DAC DEFERRAL RESPONSE

DA: 101/L002/15
Applicant: De Young Jamestown Pty Ltd
Proposal: Proposed kiosk, alfresco bar and dining area, toilet facilities, outdoor dining timber deck, boat pontoon and gangway and associated landscaping and temporary contractarian fence.
Subject land: Allotment 1001 Adelphi Terrace, Glenelg North

**RE: HMS Buffalo Redevelopment, Glenelg
DAC Request for Further Information – Engineering Response**

THE BUFFALO RESTAURANT
- EXISTING NORTH-WEST ELEVATION -

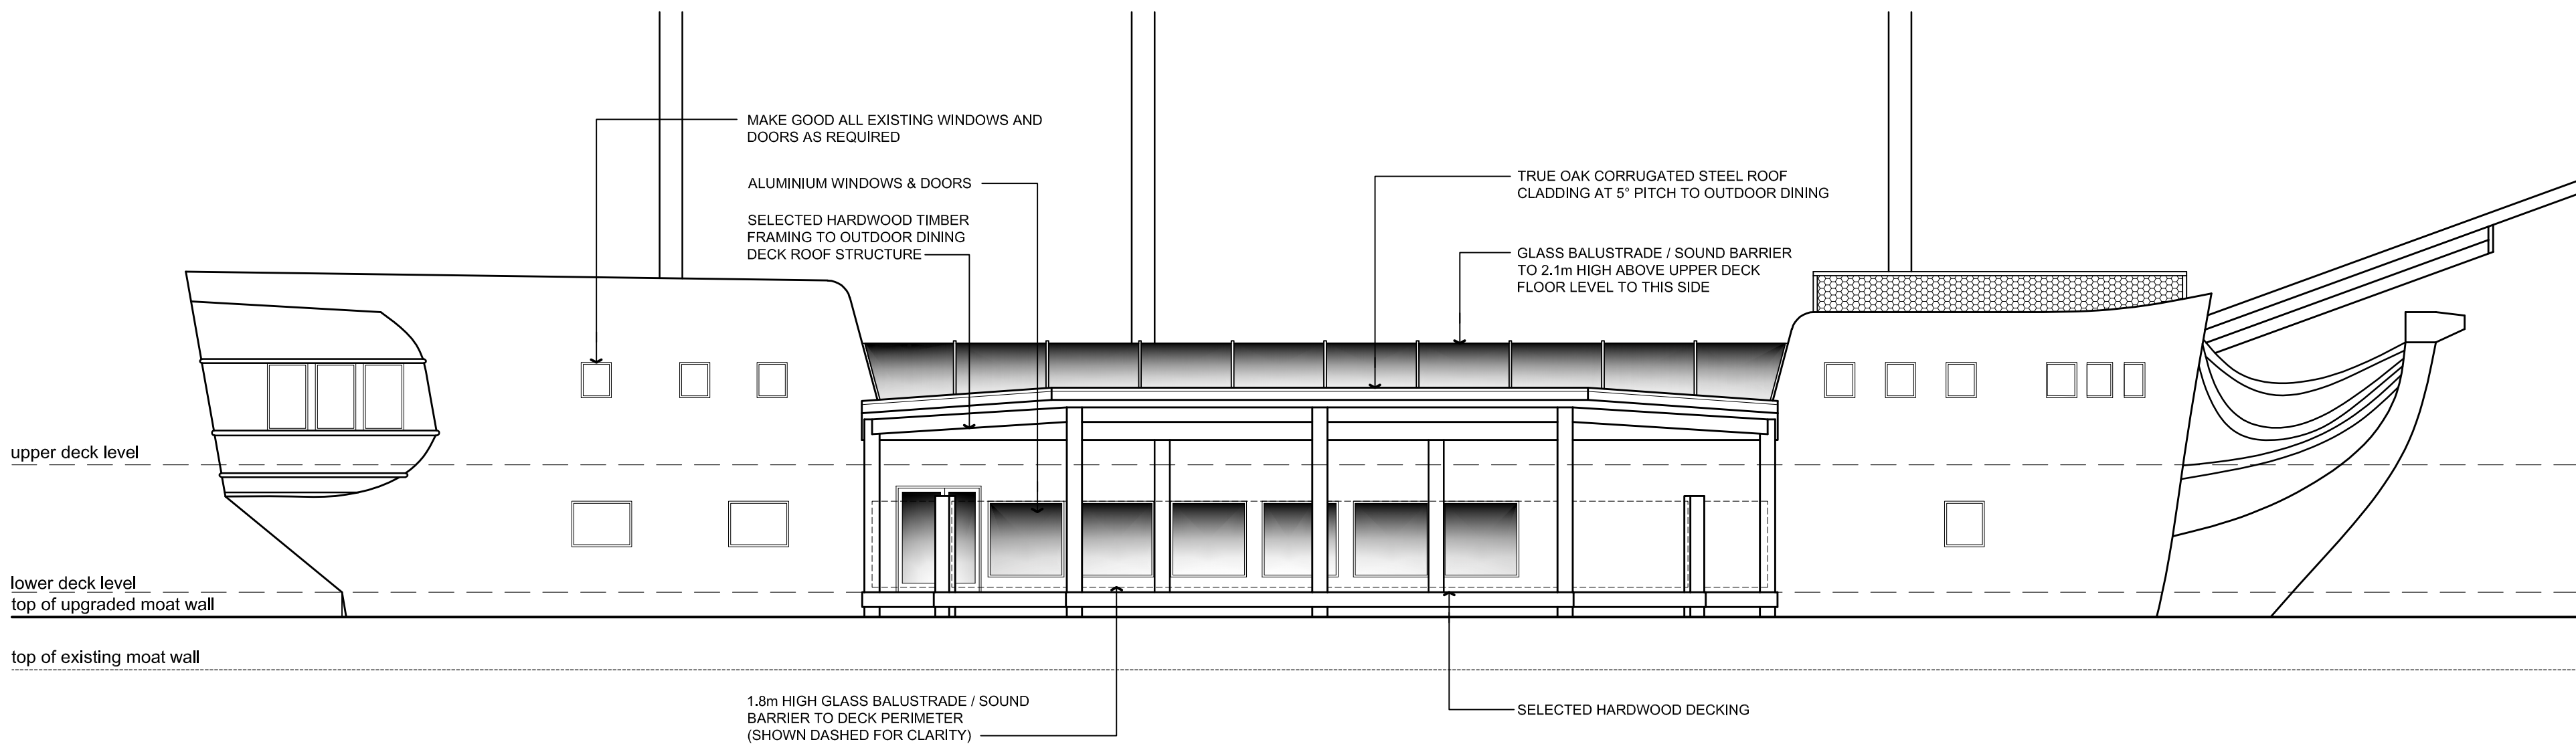
- *Clearer plans to demonstrate the interrelationship between the public realm and the development;*
- *Further details on the western façade of the Buffalo structure and any other alterations that are required for the development;*
- *Details around the resolution of the moat – landscaping, water quality;*
- *Identify the space, facilities and utilities that are located in the Buffalo structure that are integral to the wider development;*
- *Provide a consistent package of plans and documentation eg. Including resolution of noise attenuation, elevations of all facades and consistent plans.*

In order to achieve access to the outdoor deck area from within the Buffalo, alterations to the existing window openings are required. Prior to preparing this response, the applicant sought advice on the overall proposed development from Building Certifiers, PBS Australia Pty Ltd which is attached to this correspondence.

PROPOSED MOAT GARDEN

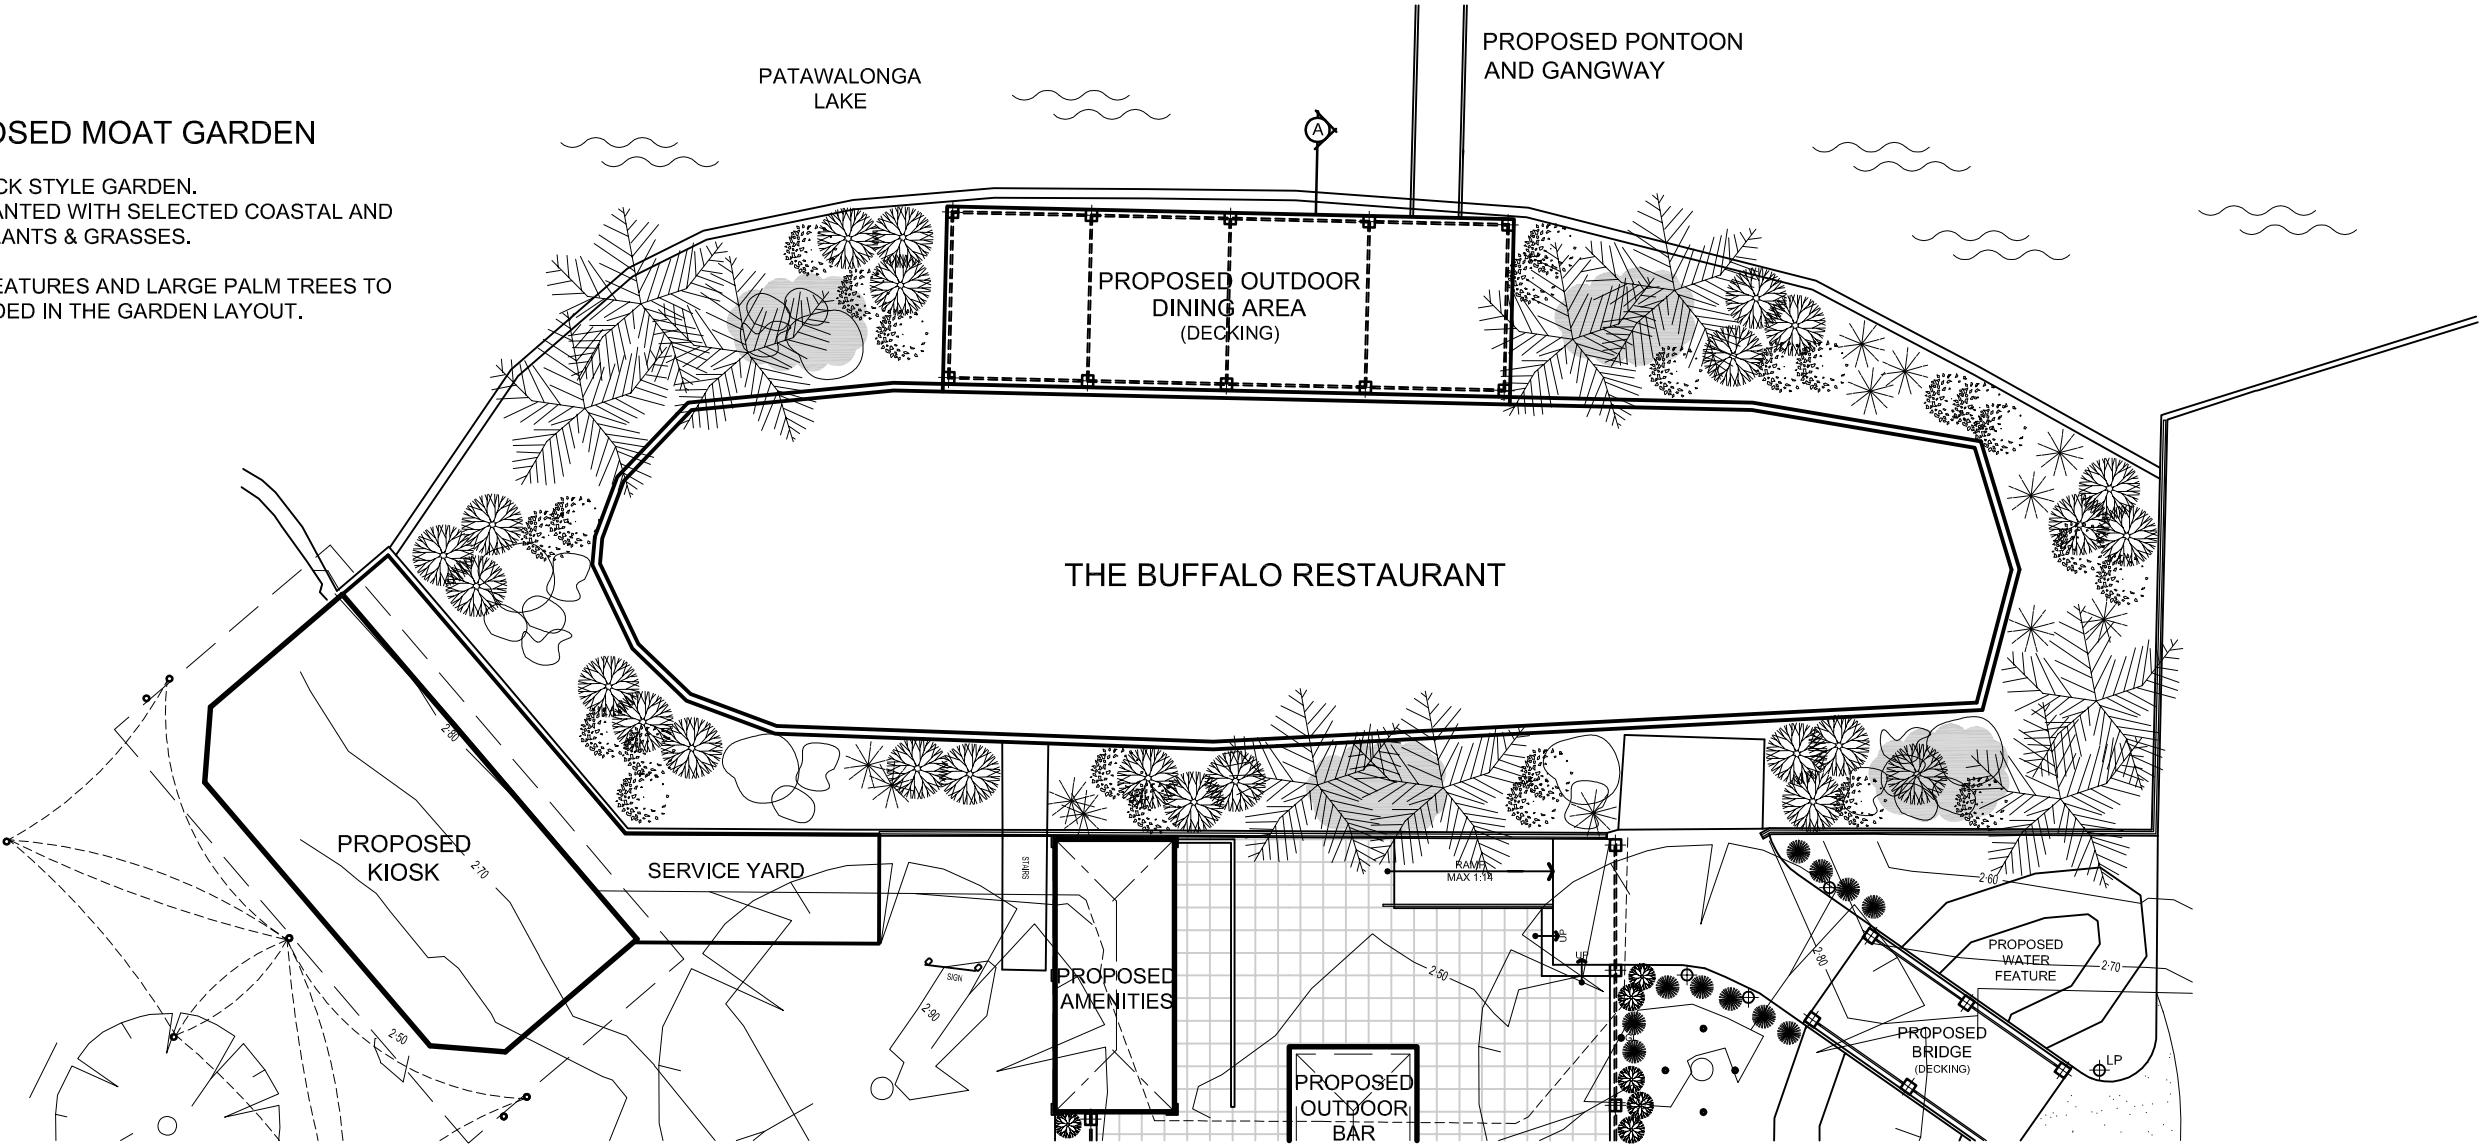
The Applicant engaged the services of Russell Consulting Engineers to provide advice in relation to the resolution of the moat and water quality outcomes. It is proposed to fill the moat with suitable clean material compacted to an adequate standard in order to raise the moat to a finished level consistent with the existing paved area to provide an improved relationship between the Buffalo structure and the public realm.

- Thickened raft slab (glass fibre reinforced) to be placed on existing surface level.
- Increase height of existing moat bund/sleeper wall to RL 2.500 AHD as per concourse level and above 100 year ARI and king tide level (2.36 AHD).
- Porous fill (no fines concrete, coarse rubble or similar granular fill) to underside of landscape zone, free draining back to lake.
- Reinforced concrete wall adjacent boat to support fill and prevent ingress of water under boat and around timber piles. Sump and pumps to remove any seepage or upwelling.

The landscape master plan prepared by Outerspace Landscape Architects also proposes a planting and landscaping scheme around the curtilage of the Buffalo and within the existing moat area (now raised to existing ground level). It is proposed to install large planter boxes within the infilled moat for the placement of larger tree species which are to be interspersed with various shrubs and ground covers. The species selection includes various sand tolerant and native plantings that are expected to thrive within the coastal environment. The landscaping will wrap around the Buffalo to not only soften the appearance of the structure, but also to frame it. The master plan specifies that the planting will give rise to a 'forest' feel around the boat, by imbedding the Buffalo structure within the Wigley Reserve whilst retaining its long standing links with the Patawalonga River by way of introduction to the pontoon.
